UNITED STATES PATENT AND TRADEMARK OFFICE

APPLICATION NO.	FILING DATE	FIRST NAMED INVENTOR	ATTORNEY DOCKET NO.	CONFIRMATION NO.
10/578,488	12/18/2006	Aaron David McKenny	TRWZ 2 00283	9420
27885	7590	02/03/2011	EXAMINER	
FAY SHARPE LLP 1228 Euclid Avenue, 5th Floor The Halle Building Cleveland, OH 44115			NGUYEN, TUAN N	
			ART UNIT	PAPER NUMBER
			3751	
			MAIL DATE	DELIVERY MODE
			02/03/2011	PAPER

Office Action Summary	Application No. 10/578,488	Applicant(s) MCKENNY ET AL.	
	Examiner Tuan N. Nguyen	Art Unit 3751

DETAILED ACTION

7. Claims 1-21 are rejected under 35 U.S.C. 102(b) as being anticipated by DE 29506835 (hereinafter Friedhelm).

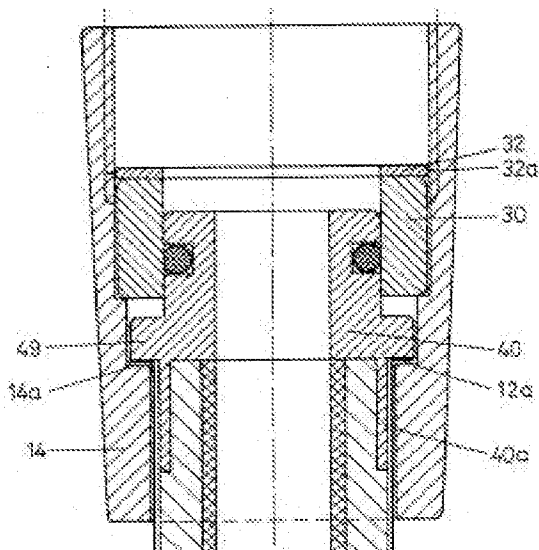
Friedhelm discloses a hose and a connector and a fastener as claimed capable of being connected to a shower base unit and a shower head unit.

First member (40); second member (30); and seal (32).
